AGENDA

President and Board of Trustees
Village of Arlington Heights
Board Room

September 4, 2018

Sheet No:
C-2.04

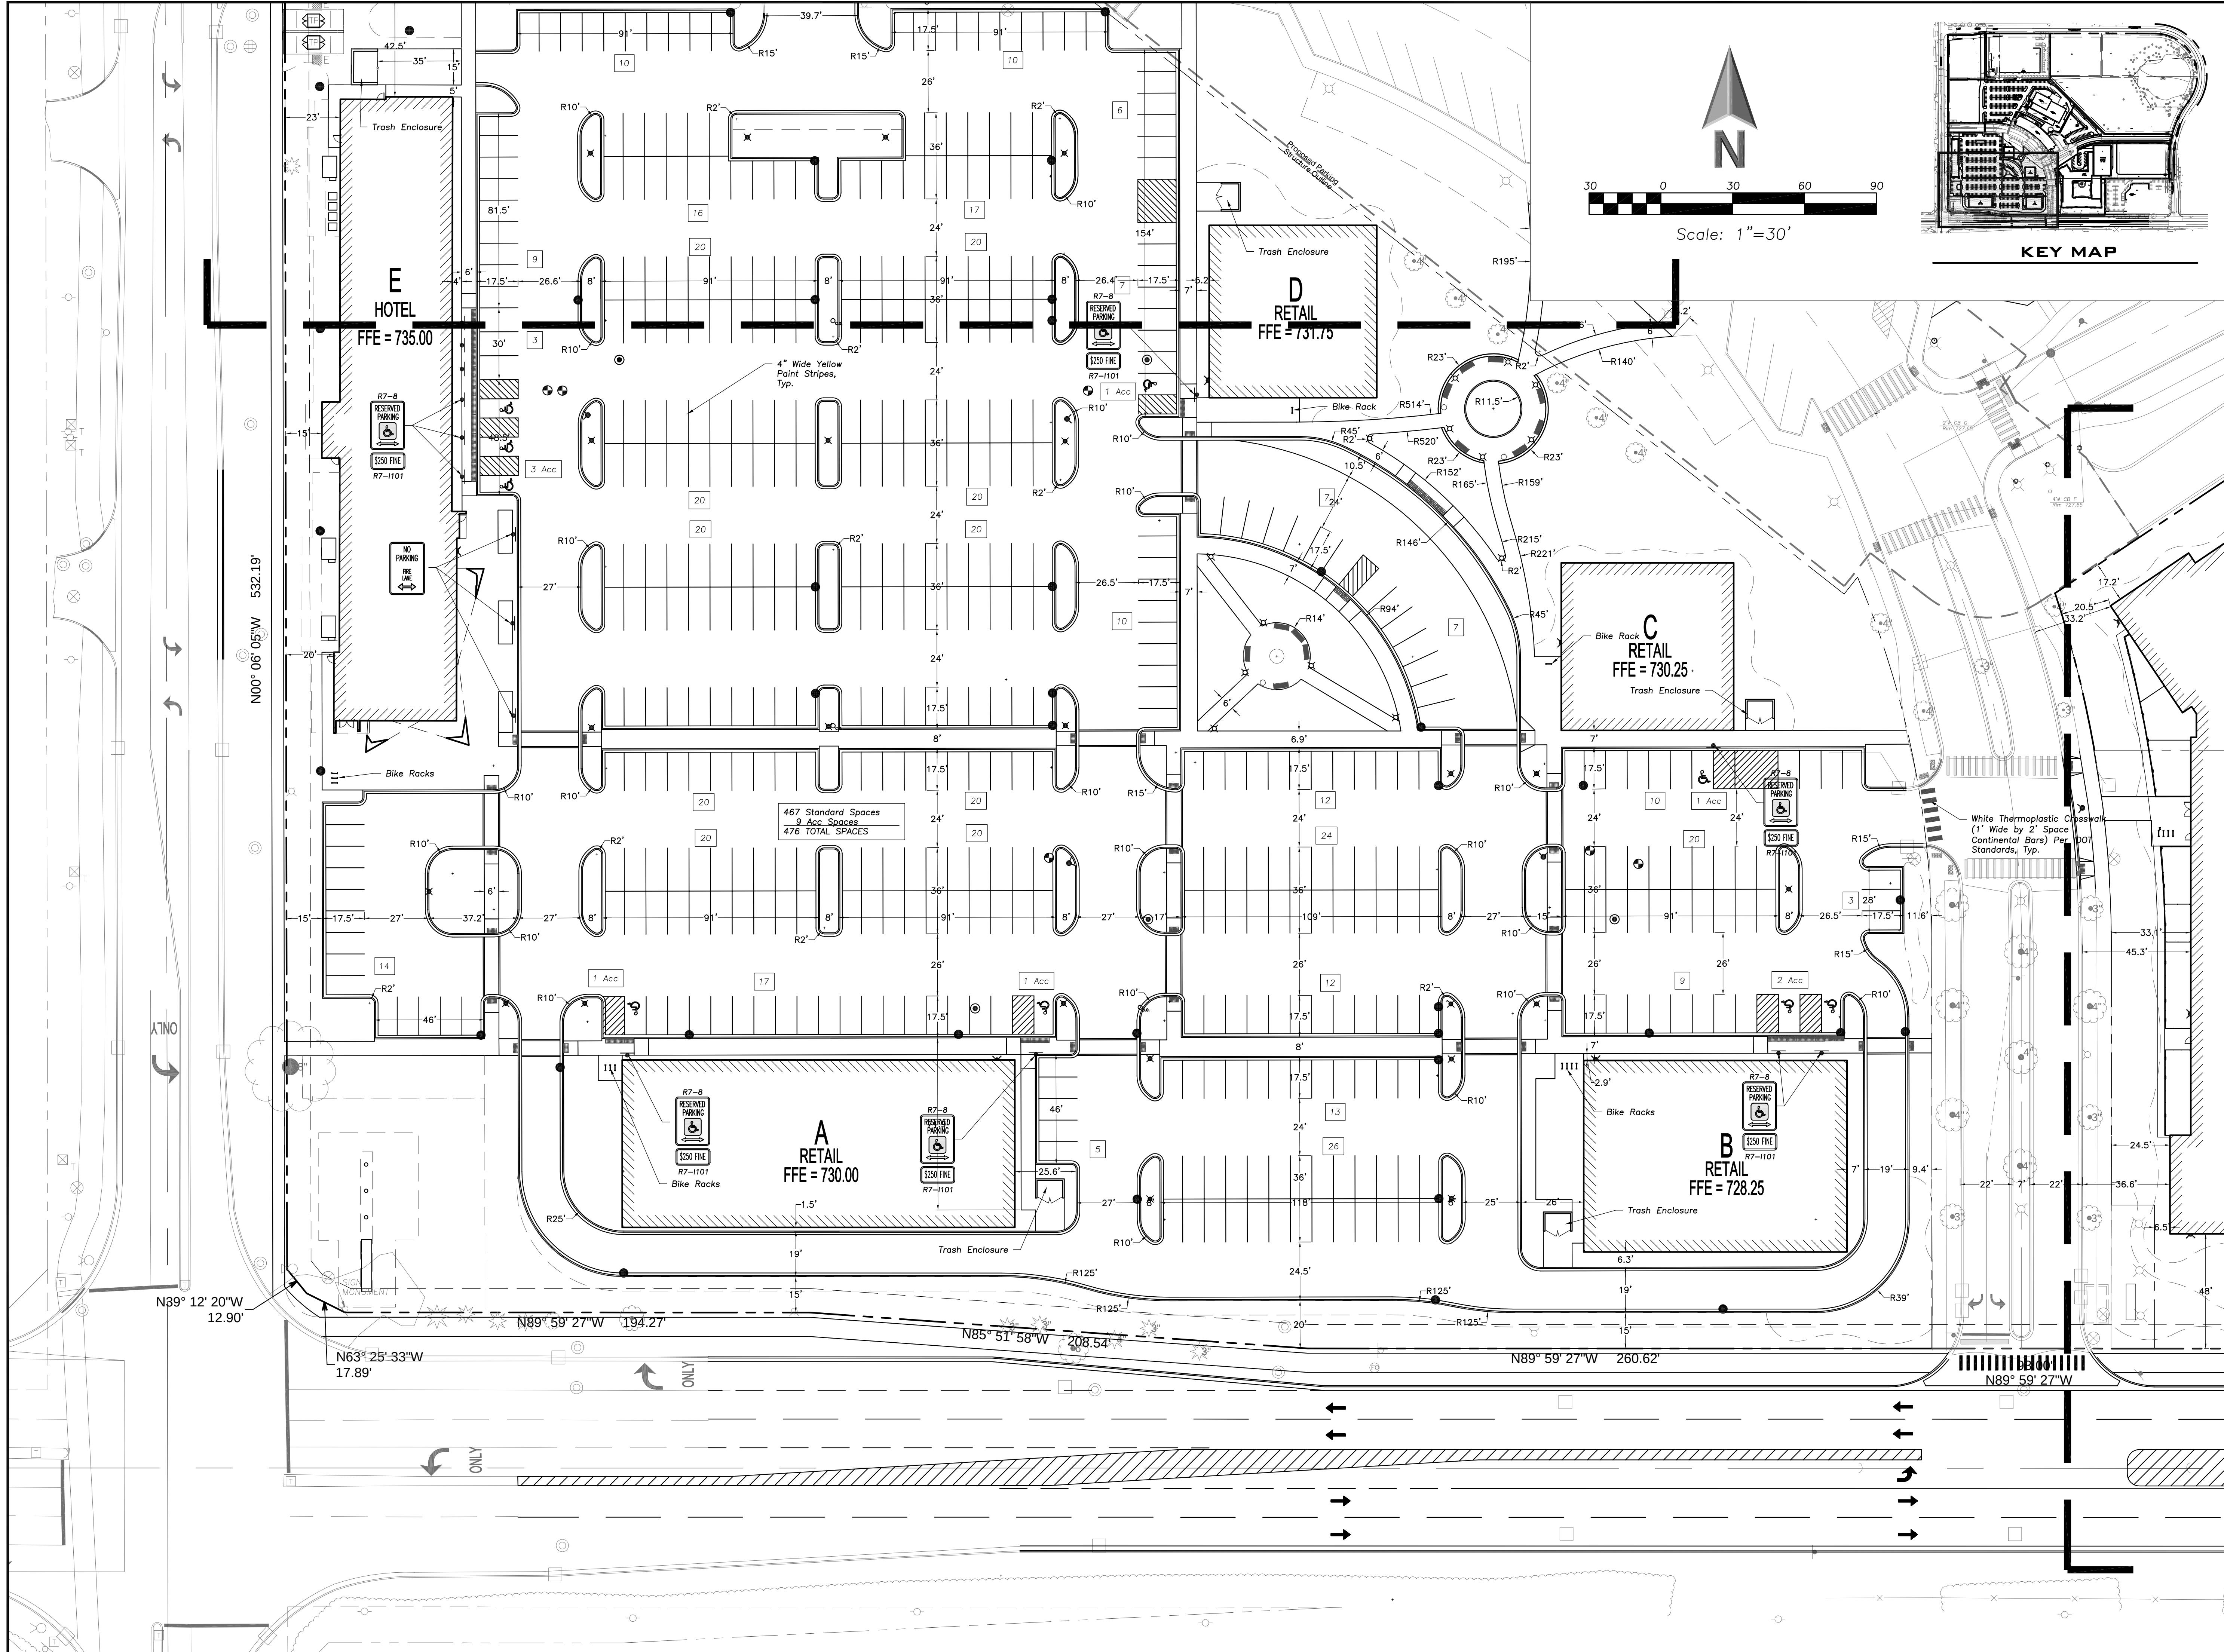
37. Sheet C-2.01: Sidewalk shall go through the driveway at Salt Creek Lane. Curb to stop on either side. Same comment for Sheet C-2.05.
38. Sheet C-5.01: The improvements to southbound Rohlwing Avenue at Euclid Avenue are shown on this plan sheet, but are not shown on any of the other plan sheets. Is this work to be included anywhere in this project, and what is the anticipated timeline?

L-2.1

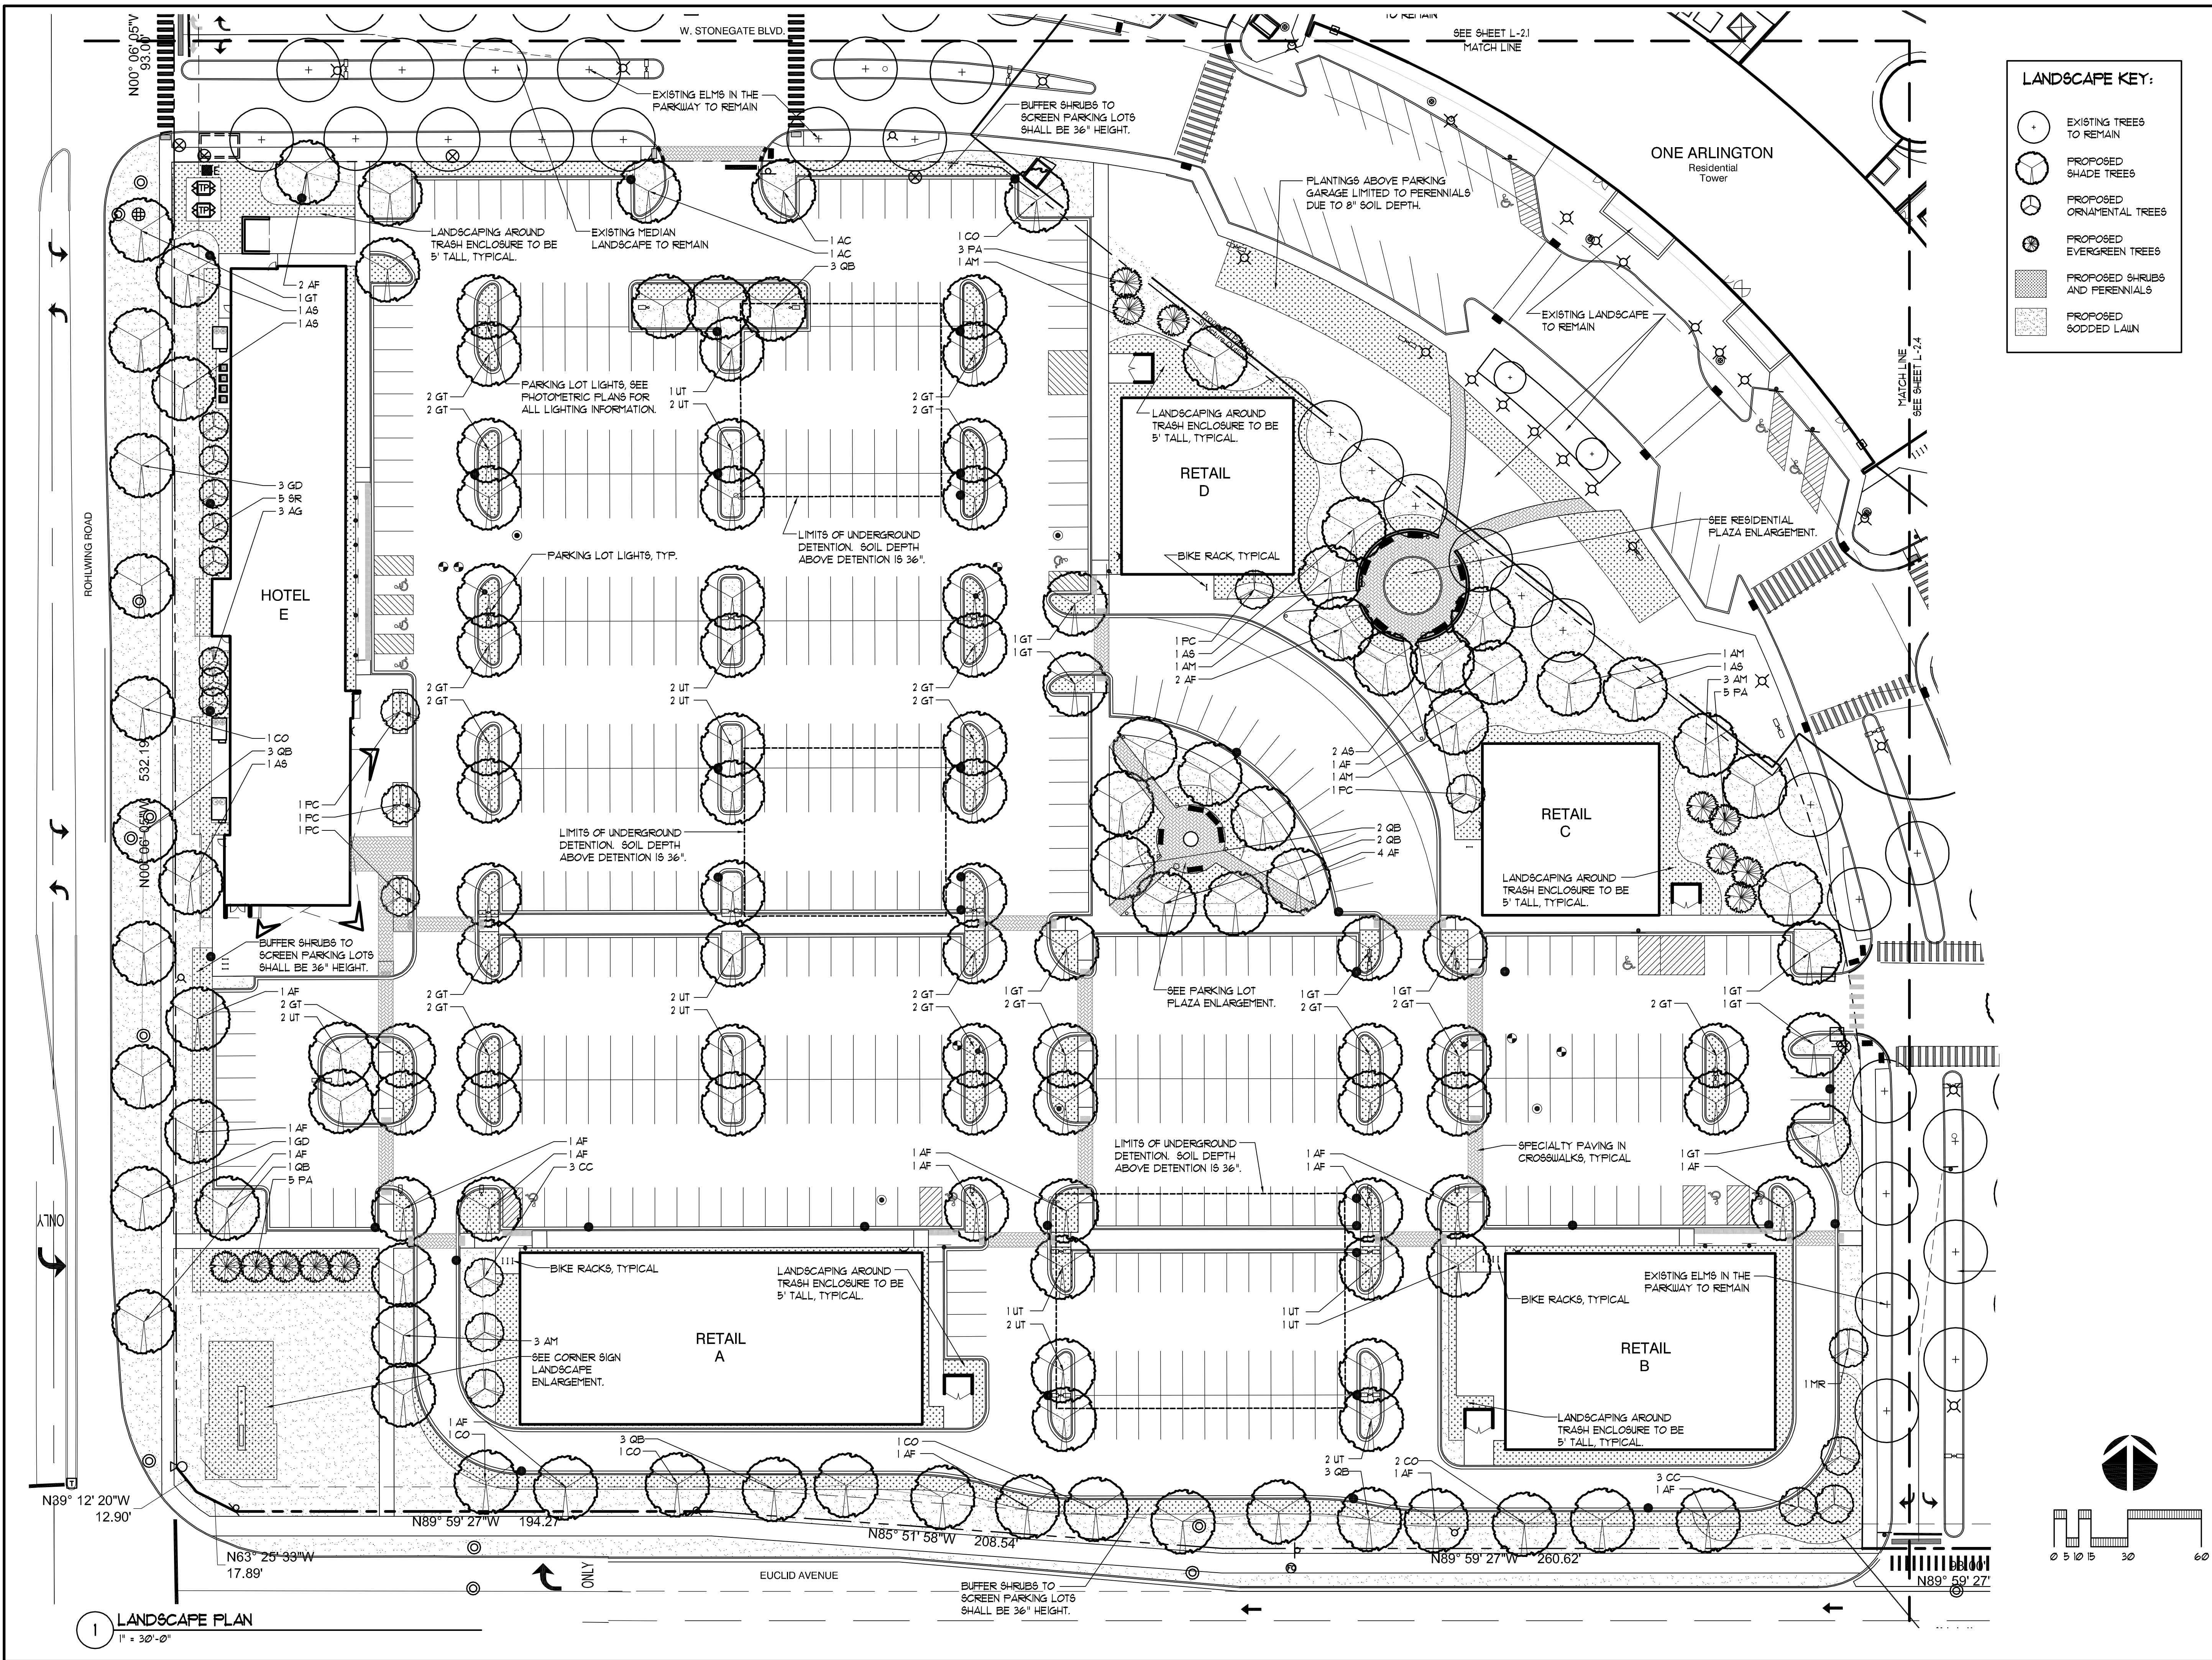
26. What is the cross-hatched feature on sheet L-2.2 on the landscape plan?

26. What is the cross-hatched feature on sheet L-2.2 on the landscape plan?

- Acknowledged. The Lot Coverage Table on sheet A010 has been updated for precision and accuracy.
57. Acknowledged. It is not our intention to relocate any existing electrical equipment. The plans have been altered to reflect the existing equipment accurately. The object at both entrances to Stonegate Blvd. is an underground water meter vault, one existing, one proposed. Landscaping is shown on all sides of the existing utility equipment. The cross hatch pattern on the landscape drawings symbolize shrubs, perennials and ornamental grasses.
